IMPROVED RELATIONSHIP TO 137-143 HERRING ROAD

3.0 REVISED SCHEME SUMMARY

STREET SETBACKS

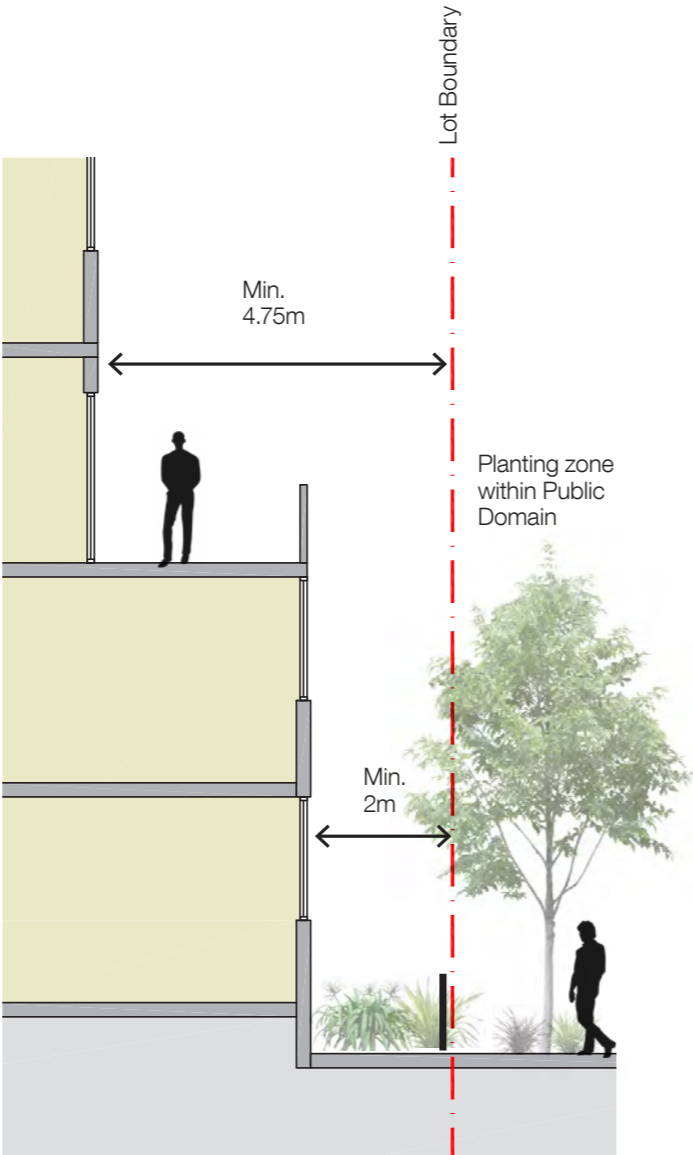
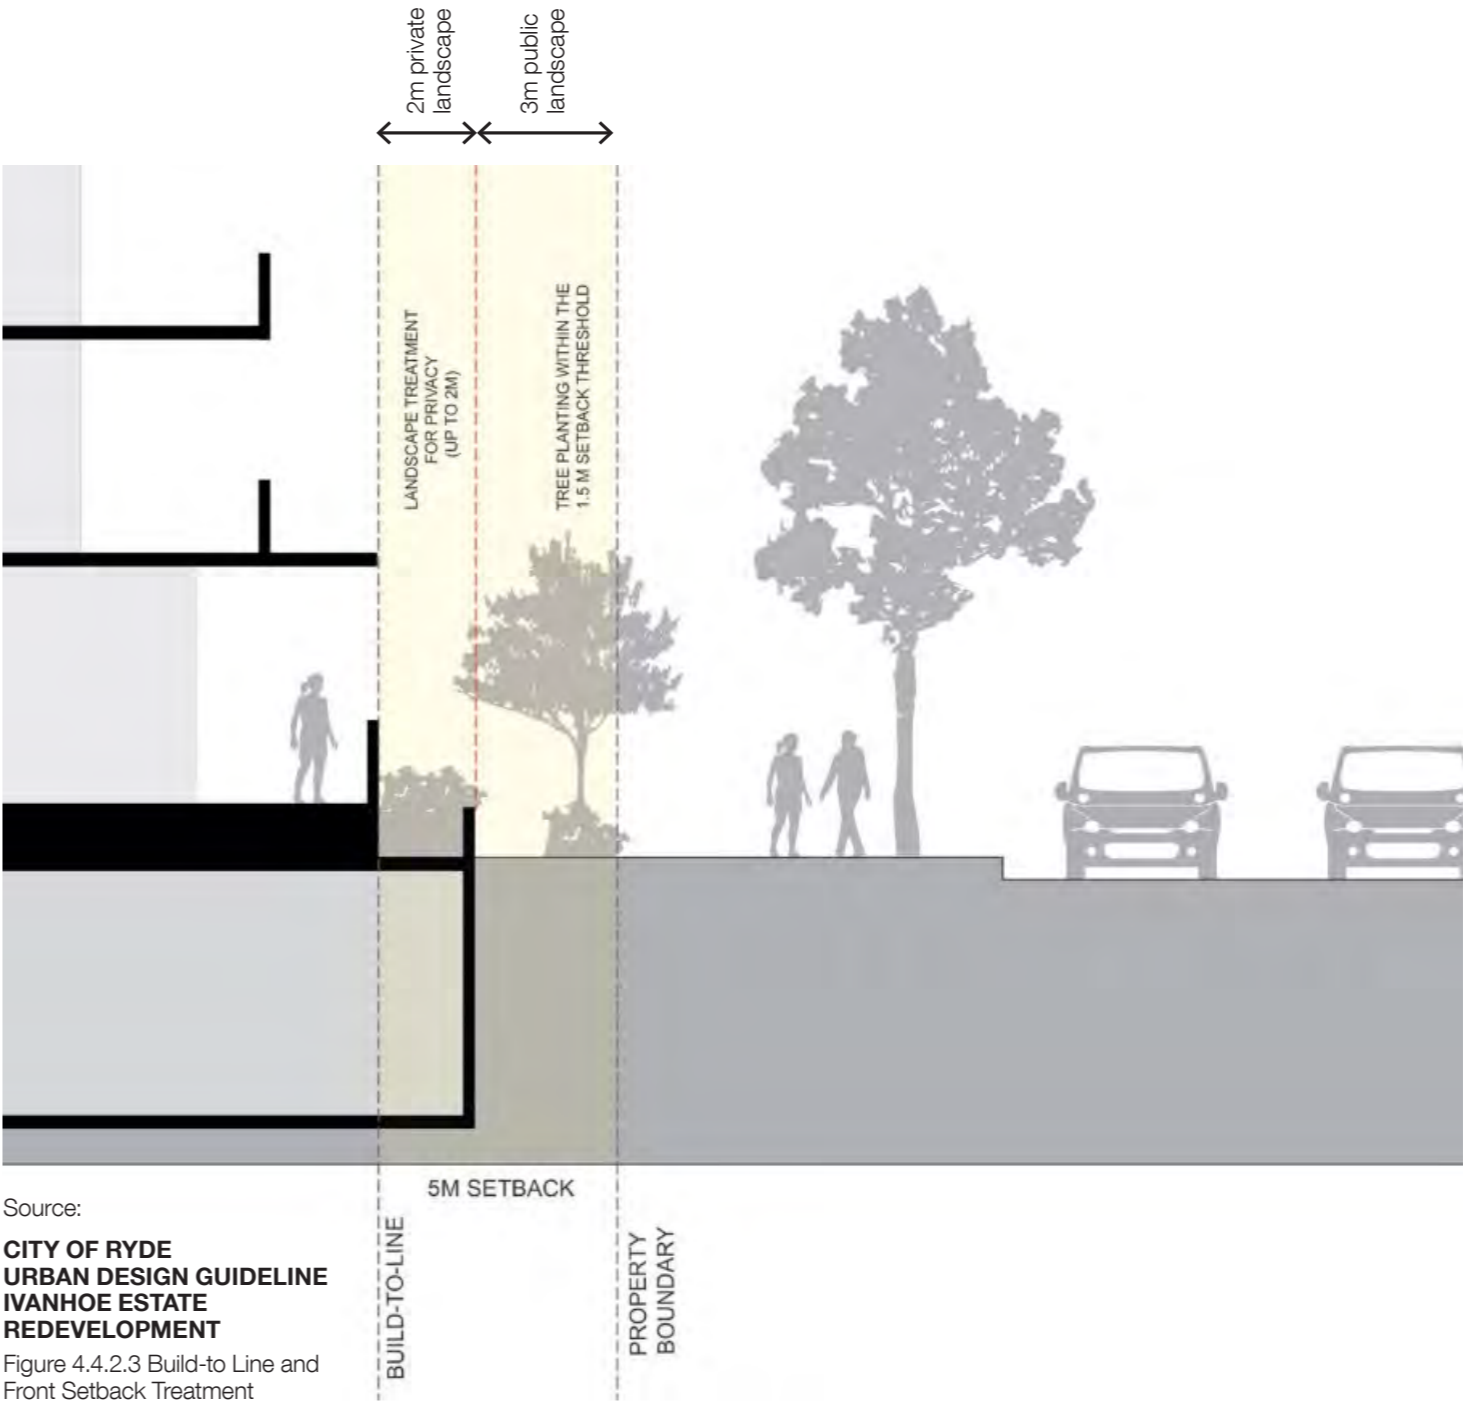
The design guidelines propose a landscaped street setback of 2m from the property boundary, with tower forms set back a further 2.75m above a 2-4 storey podium.

This aligns closely with the recommendations of ‘City of Ryde Urban Design Guidelines Ivanhoe Estate Redevelopment’, which proposes a 2m landscape treatment for privacy beyond which is a 3m landscaped edge to the street. The only difference from Ryde’s diagram is that the 3m landscaped edge is proposed within the public domain (in a wider footpath) rather than within the private domain.
